ATP Handbook

Interpretation of external surface area measurement for panel vans¹

Transmitted by the United Kingdom

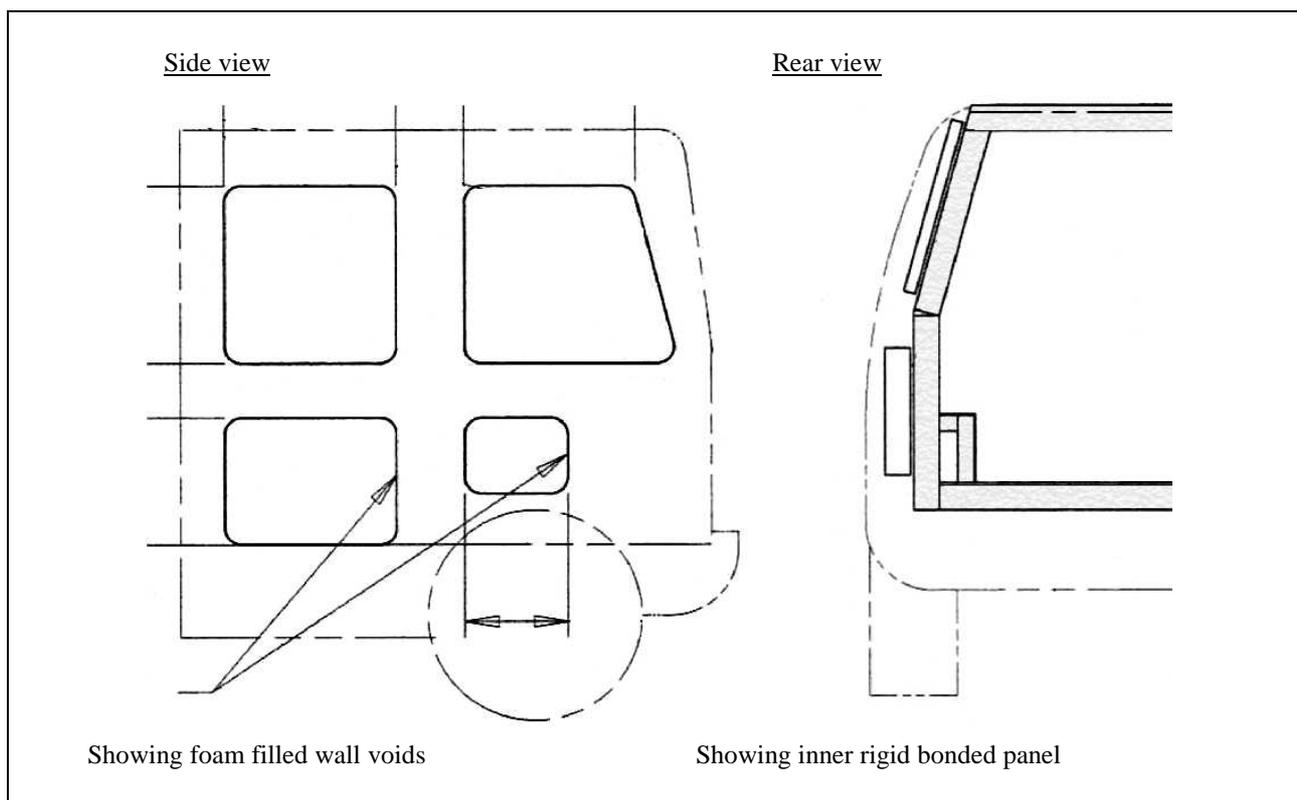
1. The thermal measurement (Model 1A of the ATP) for panel vans can provide results that are open to interpretation, the reason being that the K value is dependent on the summation of the wall surface areas.
2. The sidewall structure of a panel van incorporates steel cross members to give it strength. The voids in the side panels are often filled with a foam insulation that varies in thickness. The problem for the design is that the steel cross members thermally bridge the voids, so the main thermal break begins at the edges of the inner rigid bonded insulated panel.

3. The measurement of wall surface area is described in Annex 1, Appendix 2, paragraph 1.2 of the ATP Agreement. It states, ".....if the body is covered with corrugated sheet metal the area considered shall be that of the plane surface occupied, not that of the developed corrugated surface".
4. If the statement above is to be considered for the construction of a panel van with voids in the walls, then the surface referenced a "plane surface" should be considered as the inner-most structural steel cross members, and the "developed corrugated surface" should be considered as the external skin.
5. Then the external surface could be imagined as the inside surface area of a van with all insulation removed and lined out with infinitesimally panels.

6. To provide guidance for the measurement of panel vans in the ATP Handbook, add the following comment under Annex 1, Appendix 2, paragraph 1.2:

For the purpose of determining the thermal K value result; the external surface should be the same as the internal surface of the van when the insulation is removed and replaced with infinitesimally thin panels."
